# SITE PLAN

**Reviewed for Code Compliance**  
 Approved by: Brandon Zipser  
 Permit #: **541-21-000119-STR**  
 Date: **04/15/2021**  
 Reviewed for Lincoln City

SITE PLAN  
6600 LOGAN RD.  
LINCOLN CITY, OREGON  
SCALE: 1" = 20.00'

2400 PLAN  
 6600 LOGAN RD.  
 LINCOLN CITY, OREGON

UPPER FLOOR ENGINEERING PLAN SCALE: 1/4" = 1'-0"

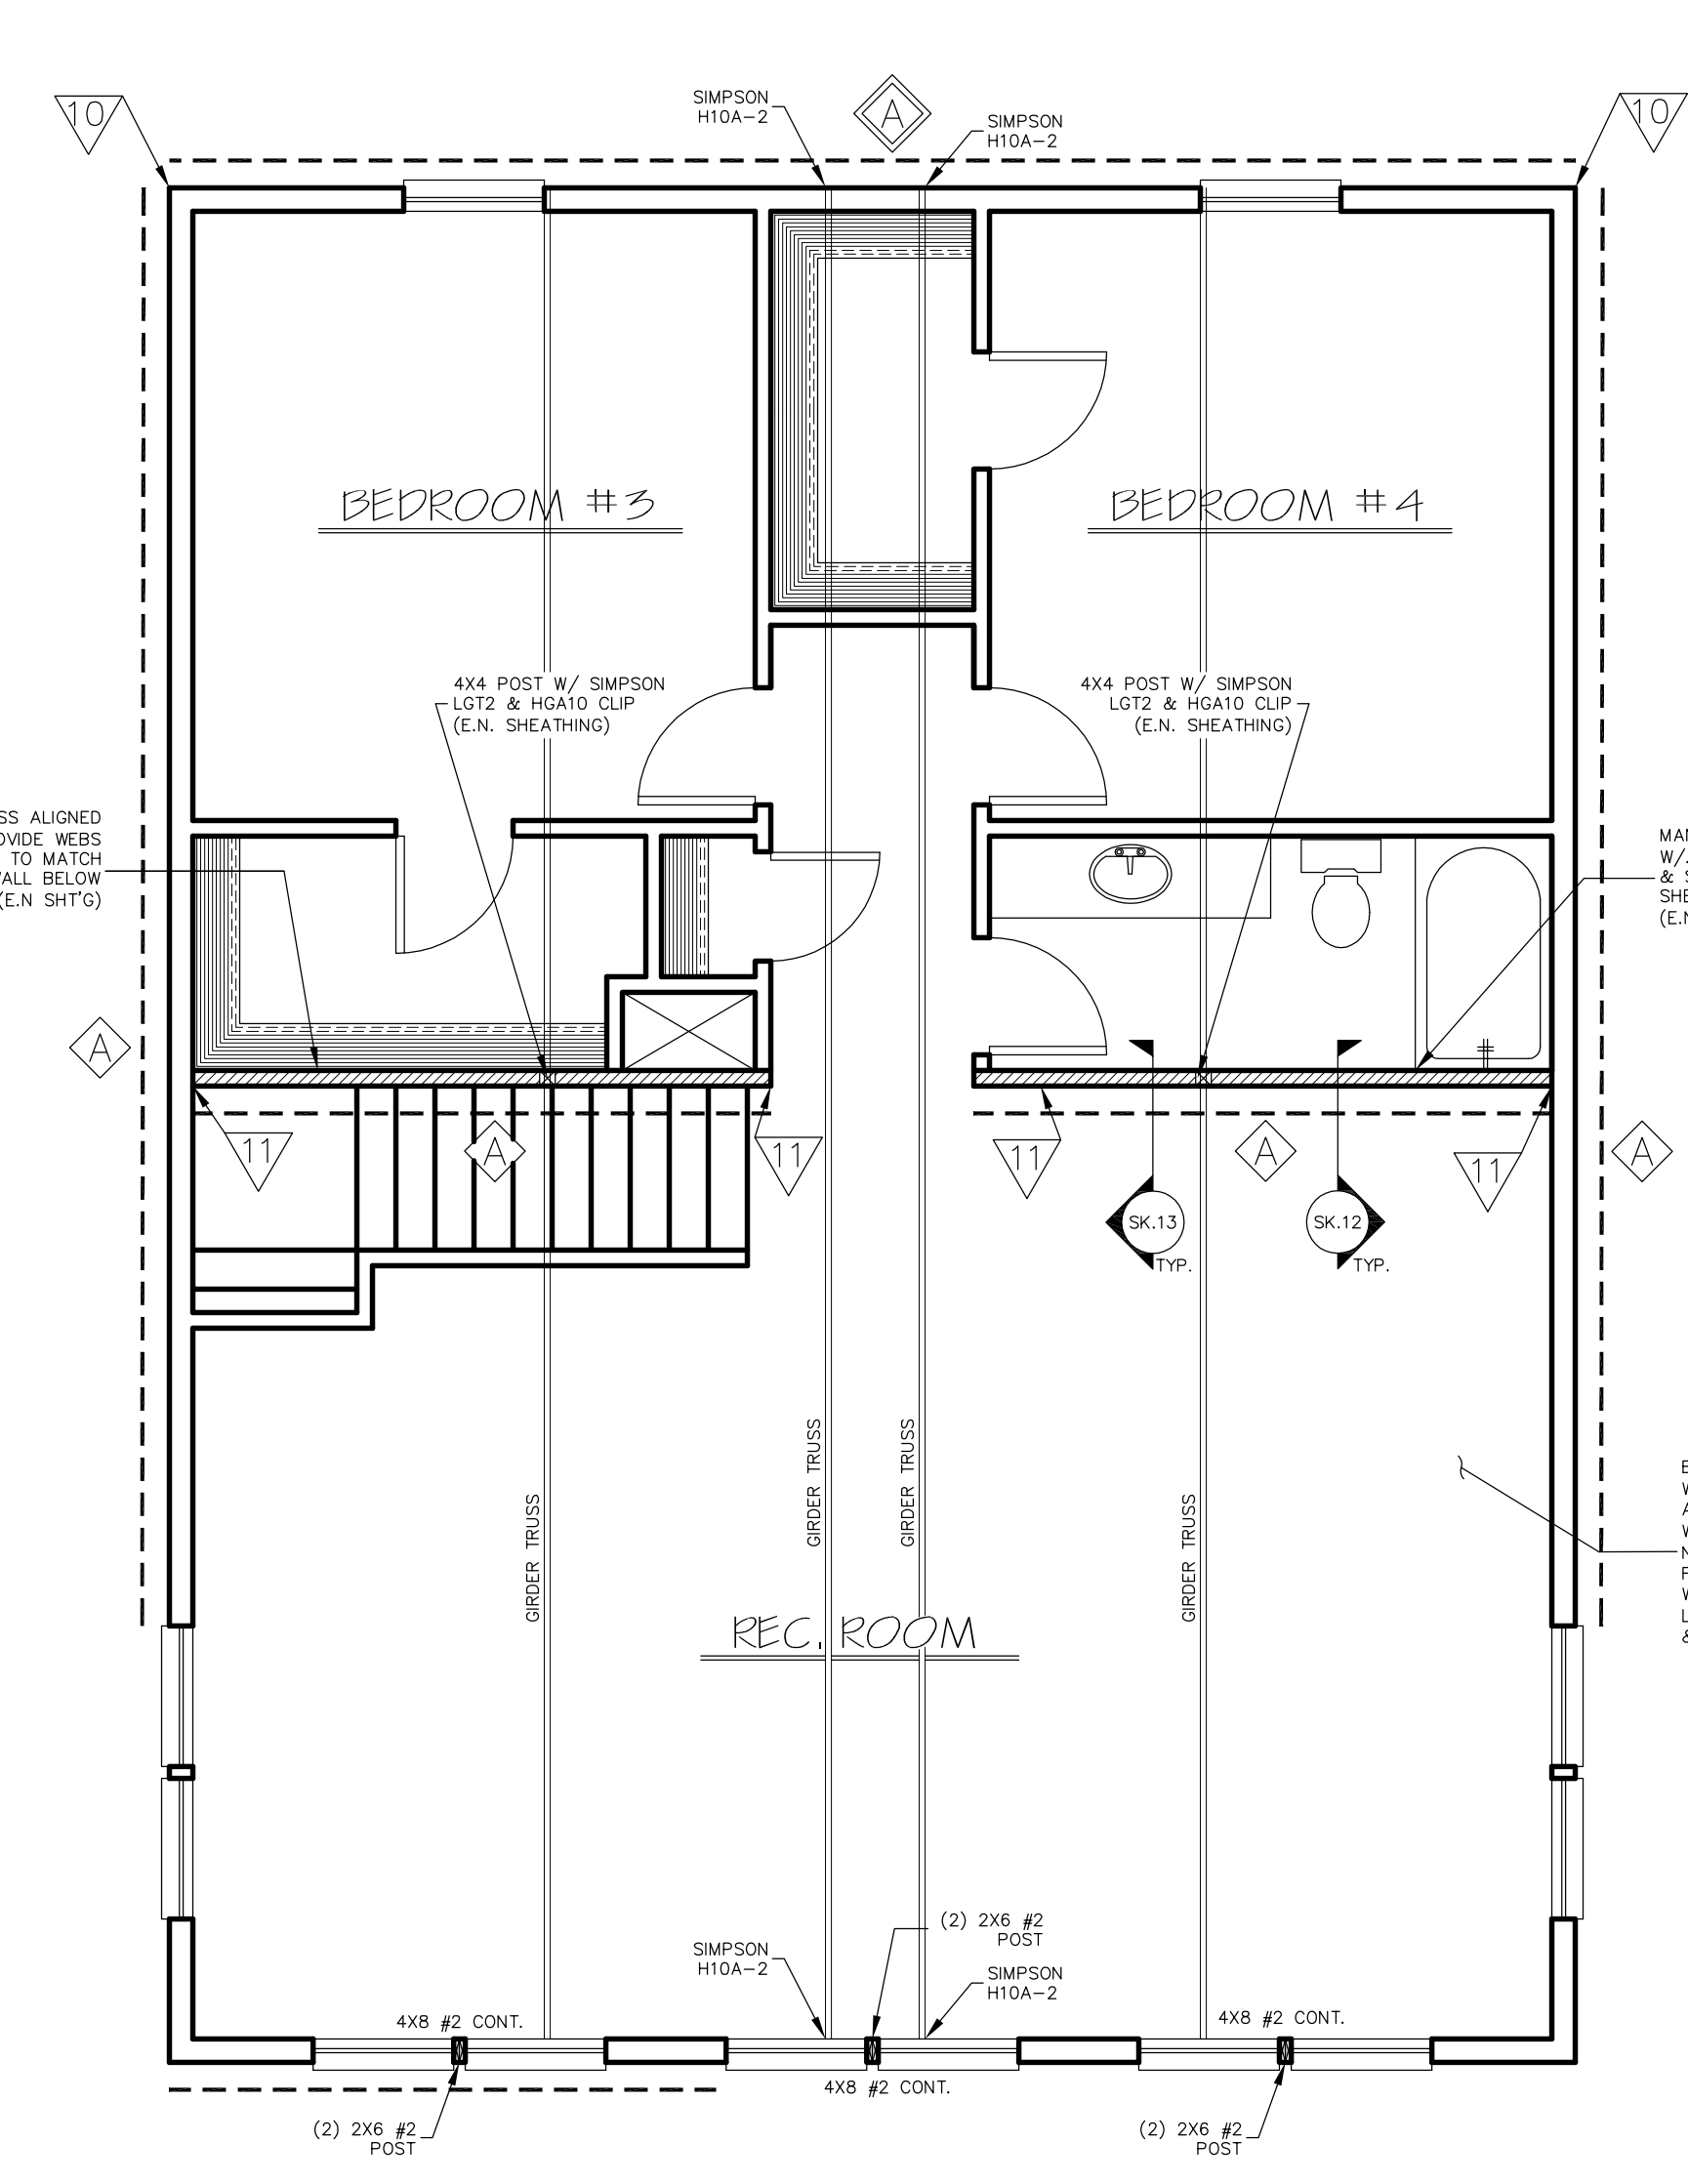
ENGINEERED TRUSS CALCULATIONS ARE REQUIRED TO BE ON THE JOBSITE PRIOR TO CONSTRUCTION

Squash block all point loads through floors to the foundation/approved footings below.

MAIN FLOOR ENGINEERING PLAN SCALE: 1/4" = 1'-0"

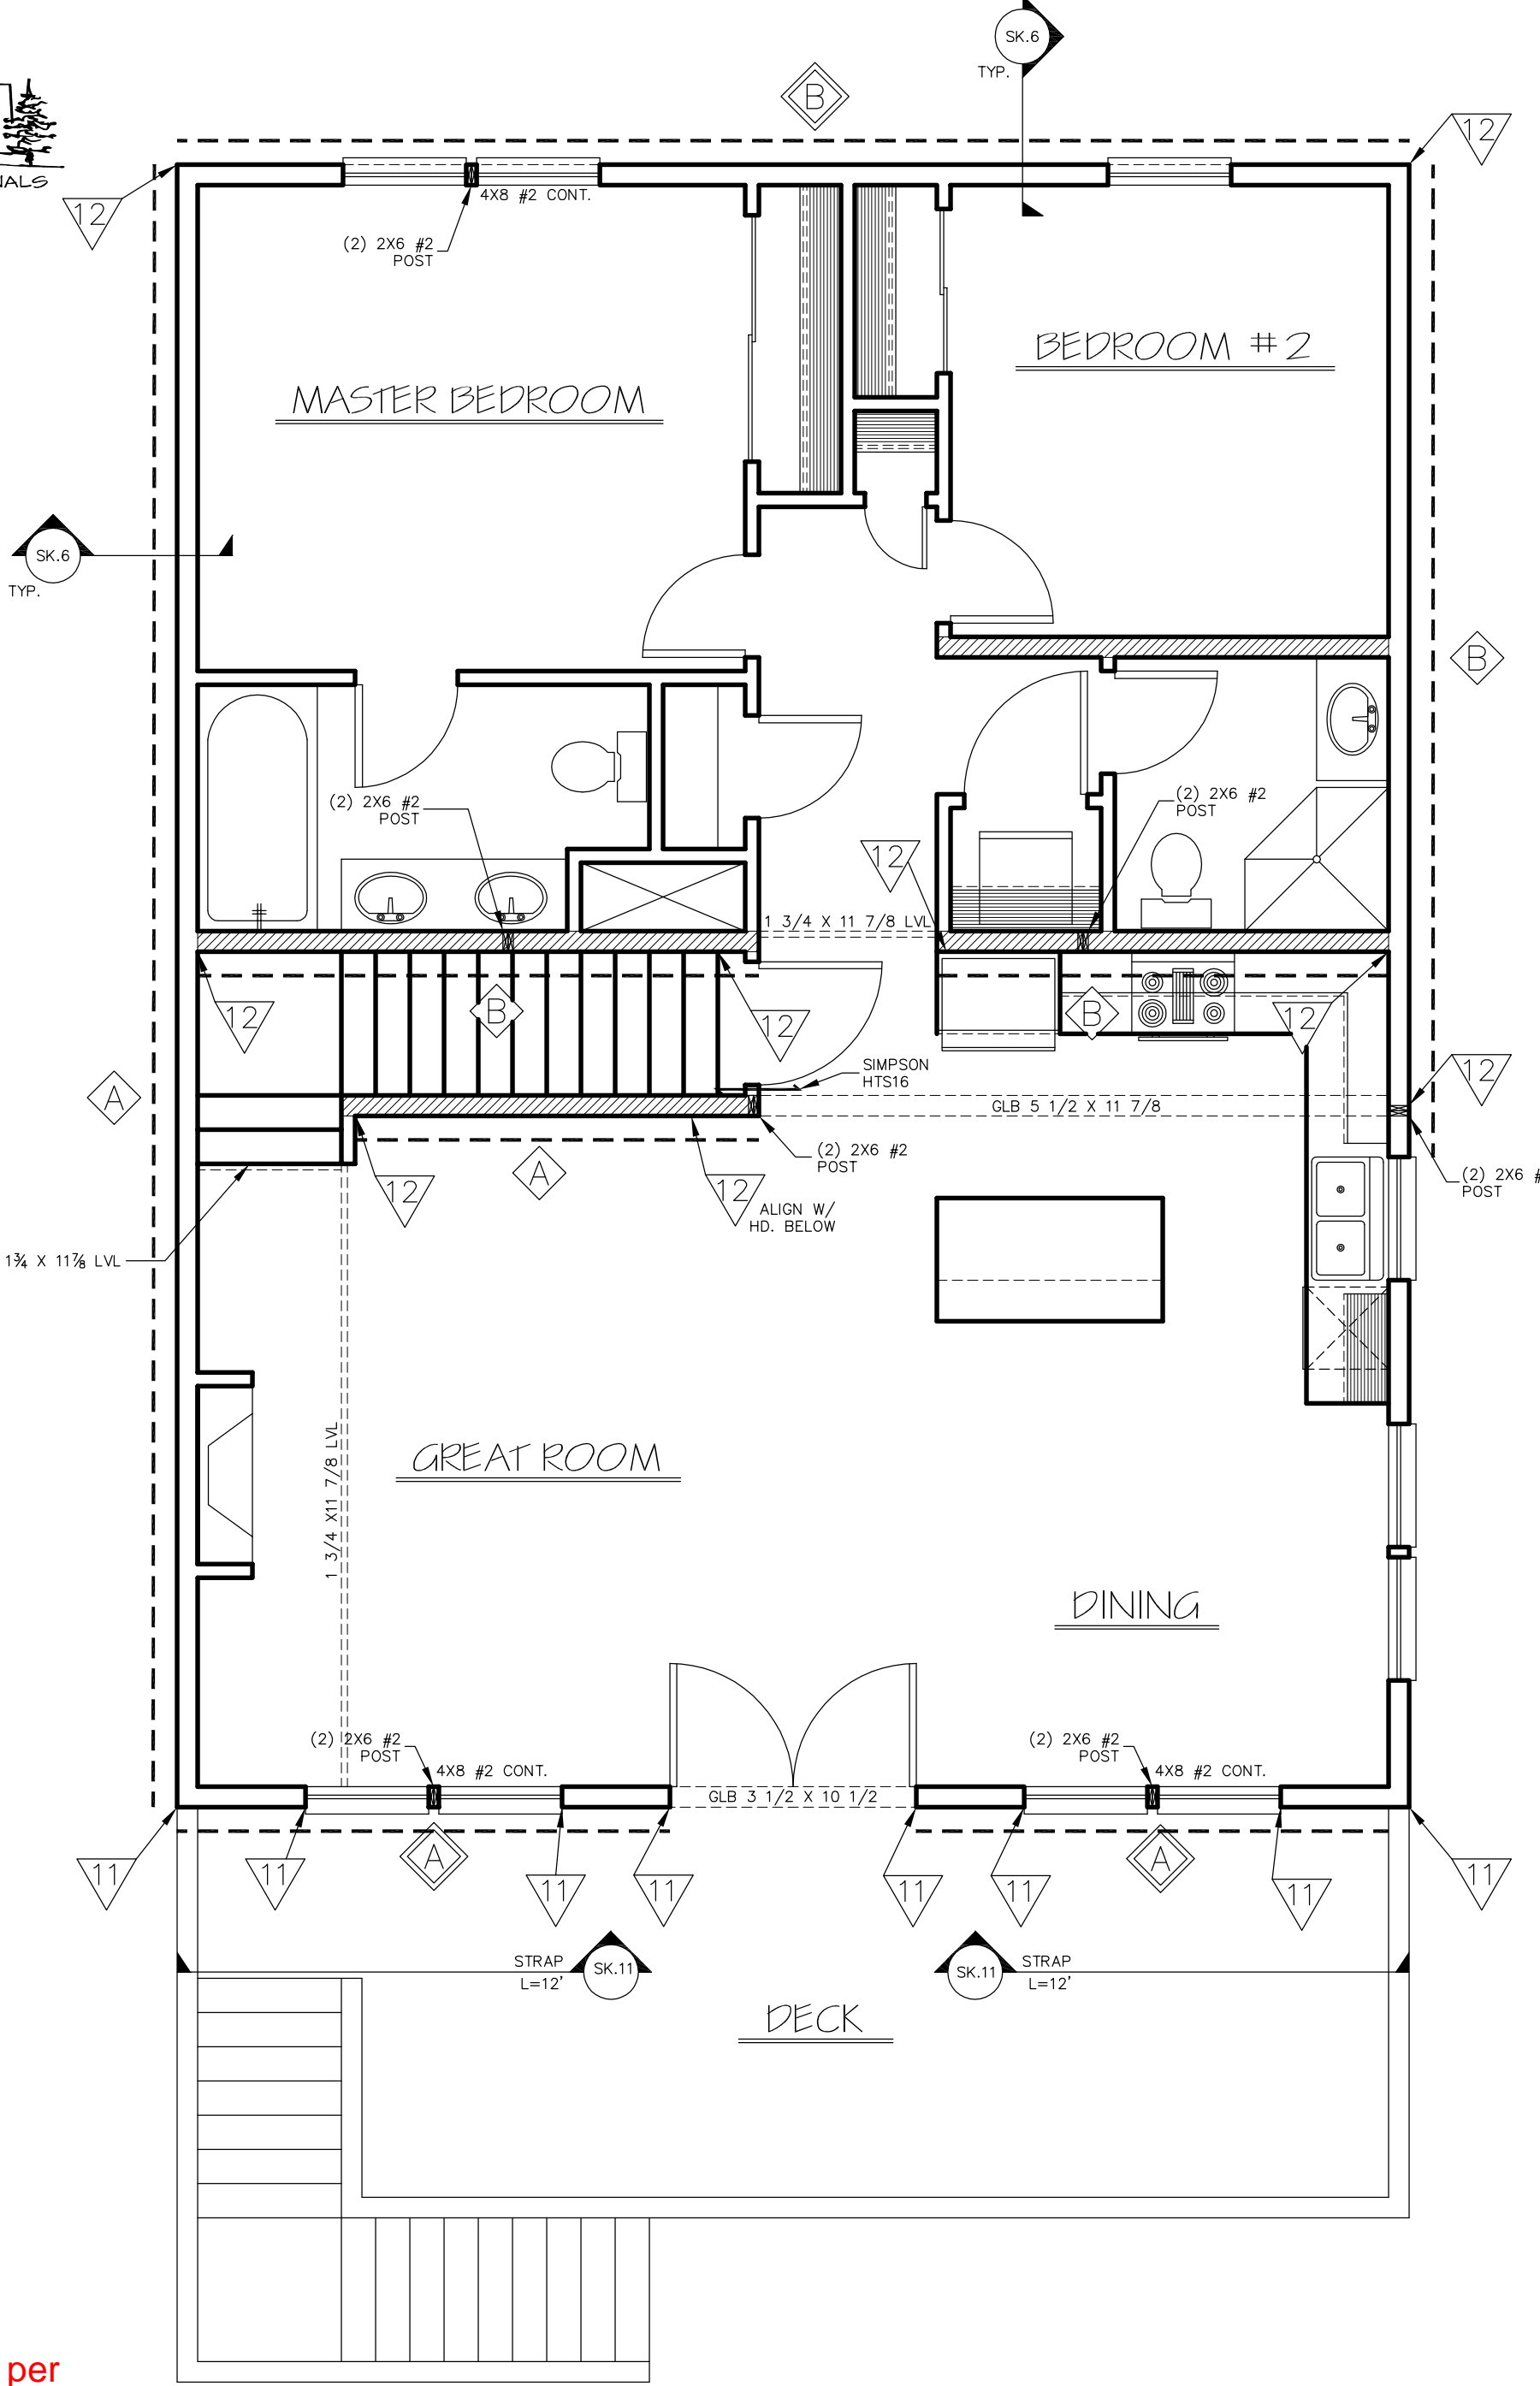
Refer to project I-Joist layouts. Install per engineering and manufacturer specs

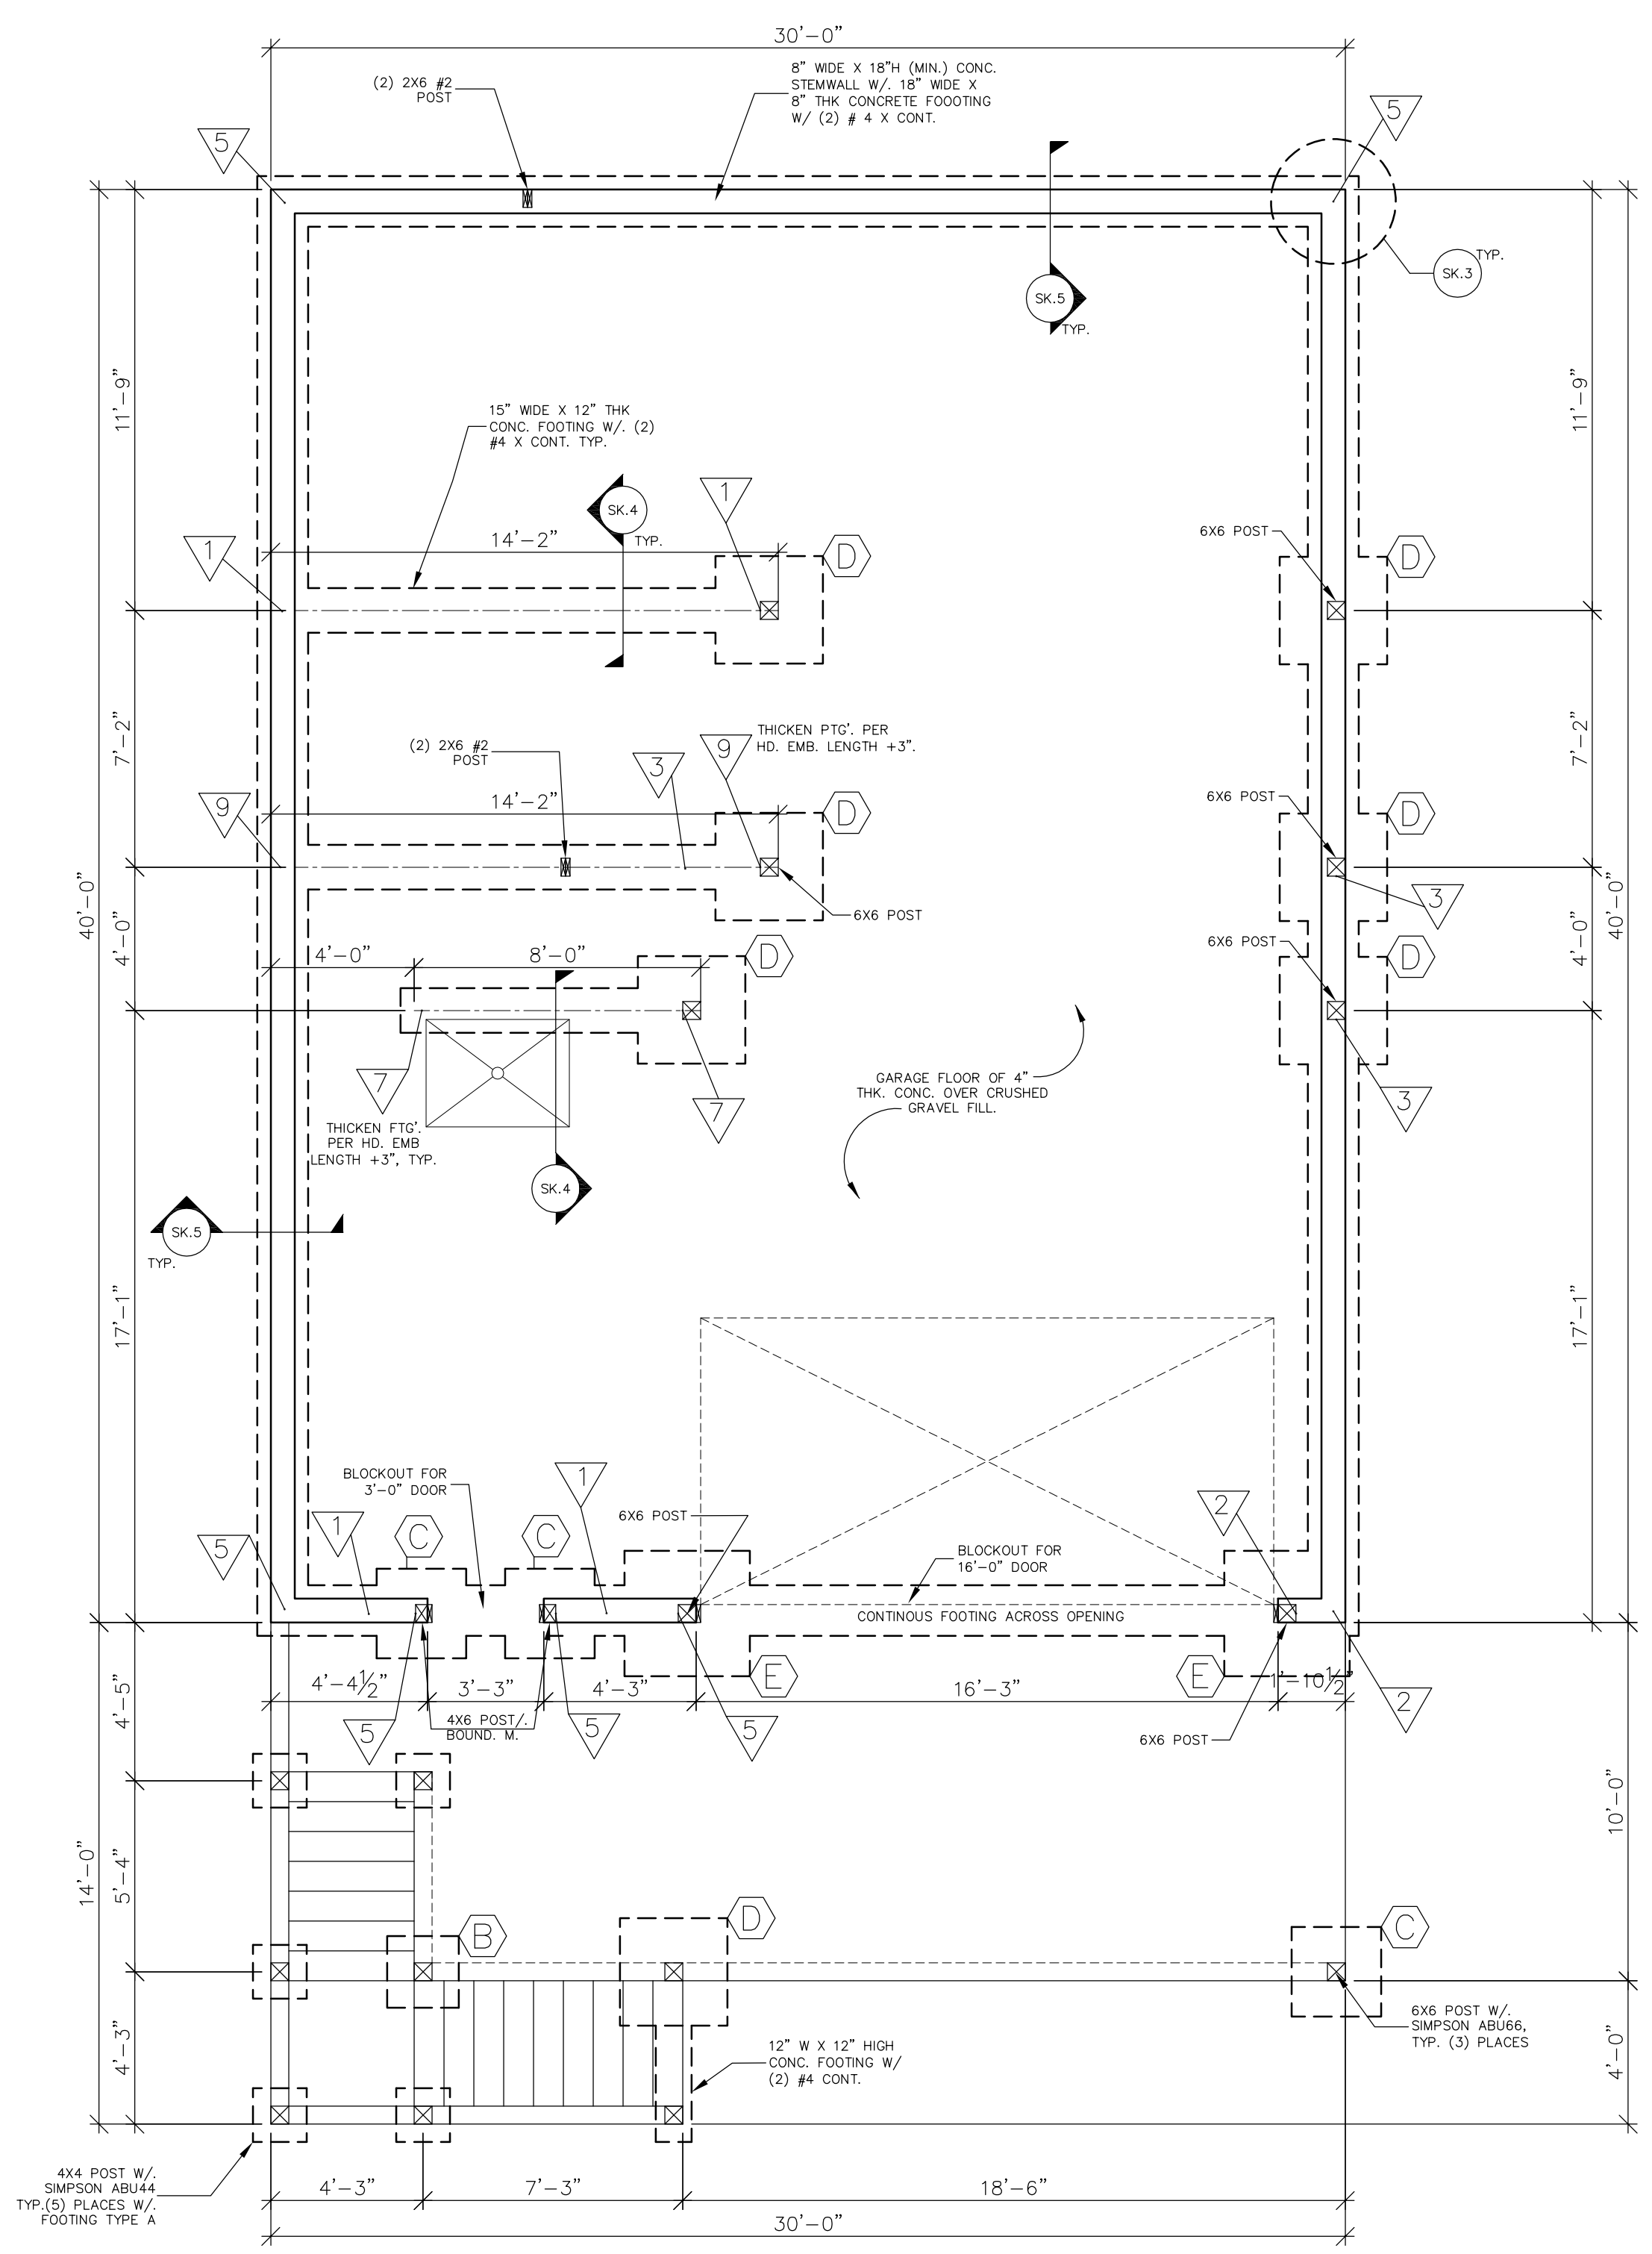
Setbacks to property lines shall be marked at the footing inspection. The contractor of record is responsible for establishing the correct property markers and setbacks.

Soil Conditions are assumed 1500psf. If at excavation soils issues are found, consult a qualified engineer and the jurisdiction.

EXPANSIVE SOILS OR OTHER SOIL ISSUES MAY BE PRESENT ON YOUR PROPERTY (BUILDING SITE). THE OWNER OR PERMIT HOLDER IS RESPONSIBLE TO VERIFY IF ANY SOIL CONDITIONS ARE PRESENT PRIOR TO FOUNDATION/FOOTING INSTALLATION.
